VEPCO NOMAD CODE AND MODEL SUPPLEMENTAL INFORMATION.

Docket # 50-280
Control # 8407170305
Date 7/6/84 of Document:
REGULATORY DOCKET FILE

RESPONSE TO QUESTIONS AND COMMENTS ON VEPCO NOMAD CODE AND MODEL (VEP-NFE-1)

FIGURE 1.1

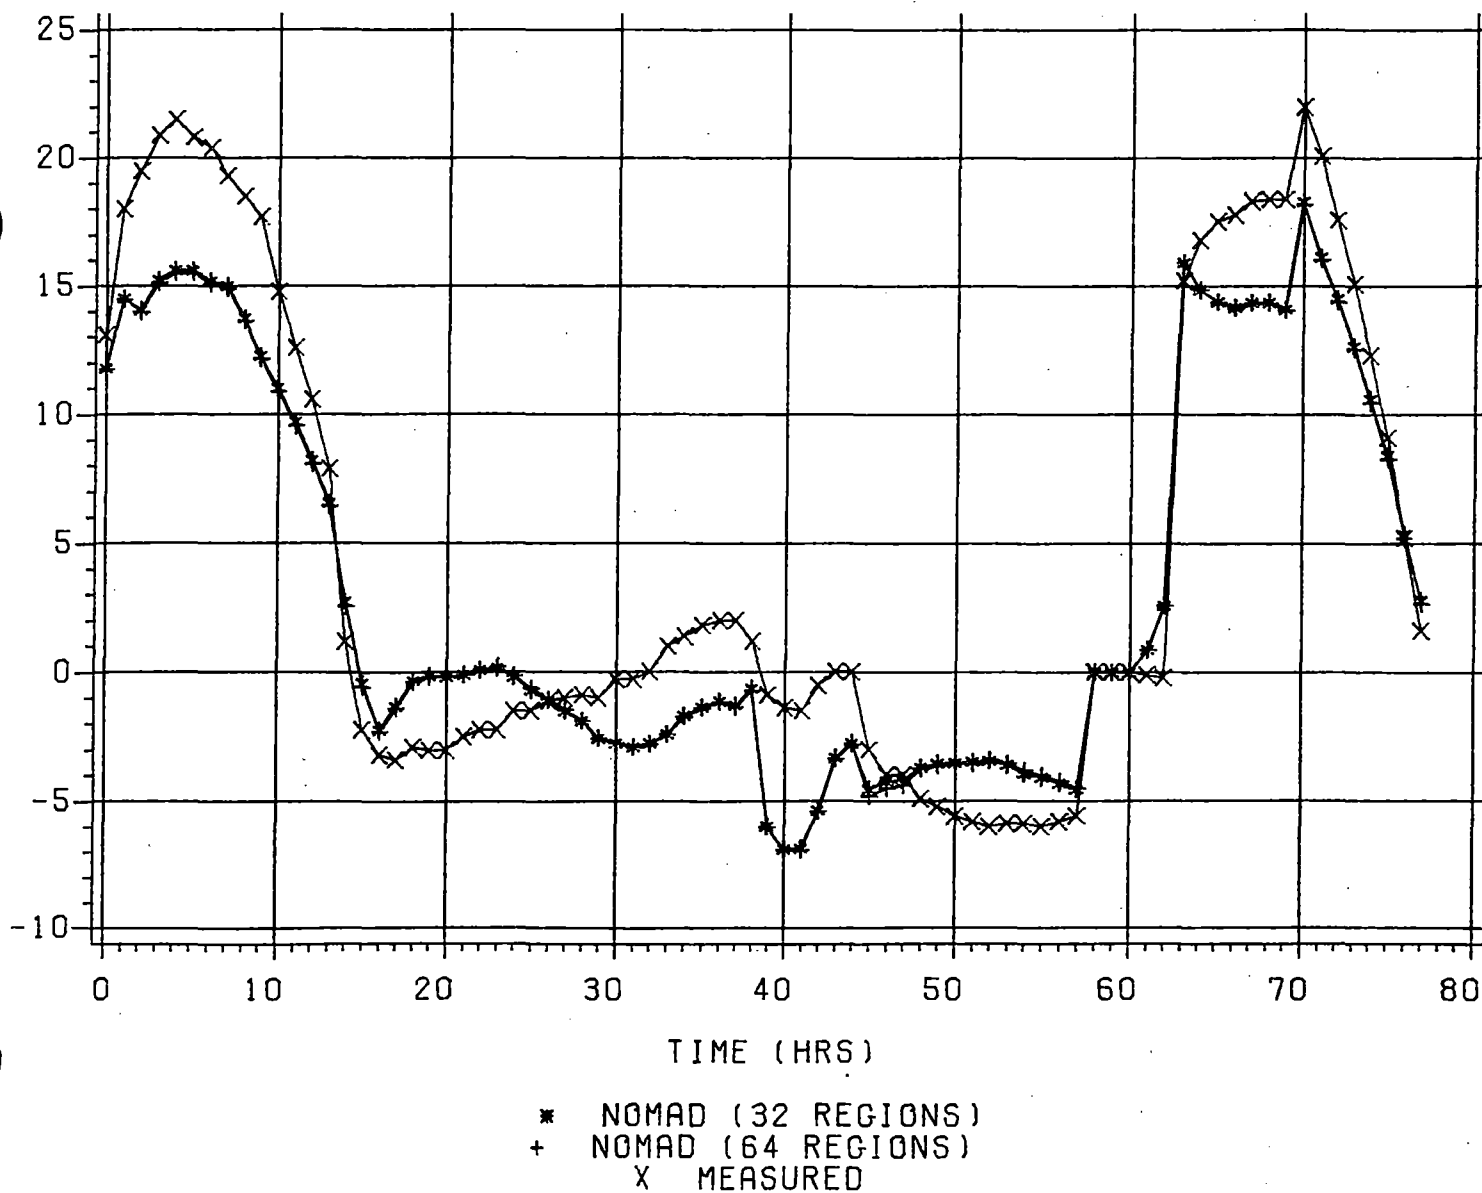
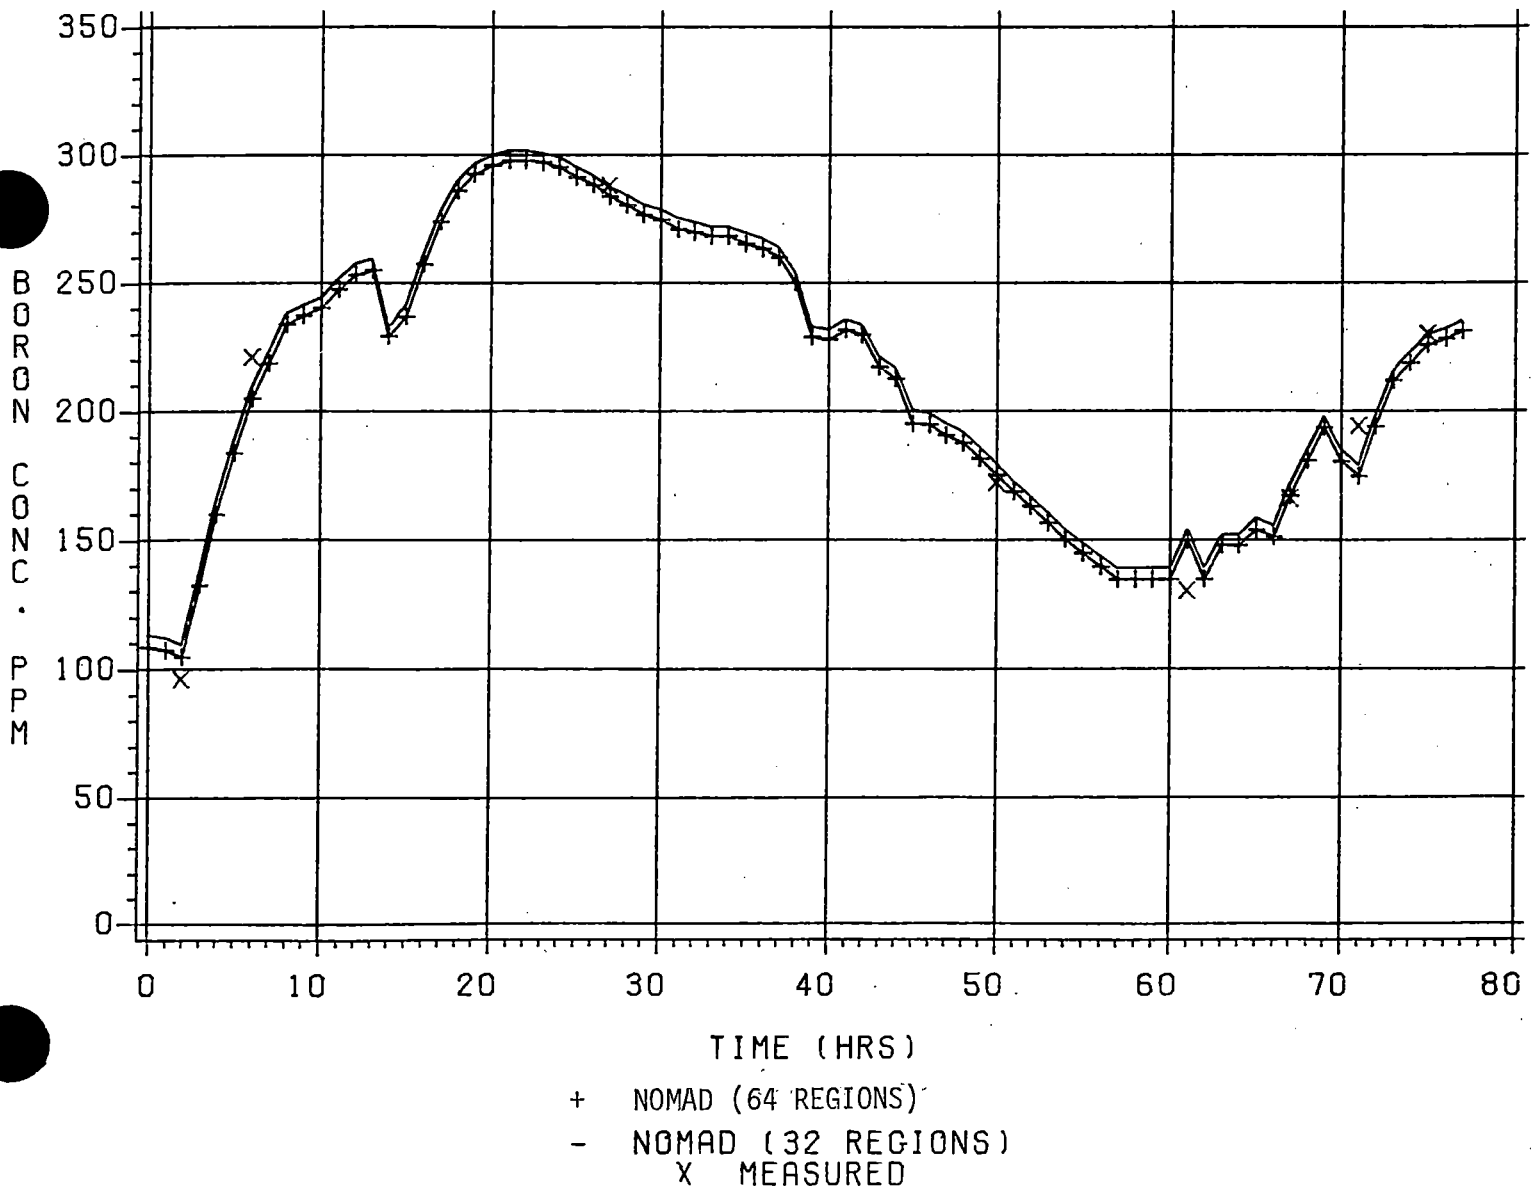
Question 1. The NOMAD model represents the fuel by 32 axial regions.

This implies an axial mesh spacing of more than 11 cm which is large for an explicit 2-group, finite difference code, particularly in light of studies of the dependence of finite difference generated results to mesh spacing.

To demonstrate the accuracy of the 32 axial region model, one of the load follow maneuvers from Section 5.6 (N1C3 Shutdown/Return to Power Case 1) was performed with the 32 axial region model and with a 64 axial region model. Figures 1.1 and 1.2 show virtually identical results for delta-I and critical boron concentration throughout the case. Figures 1.3 through 1.8 show comparisons of axial power distributions calculated at specific
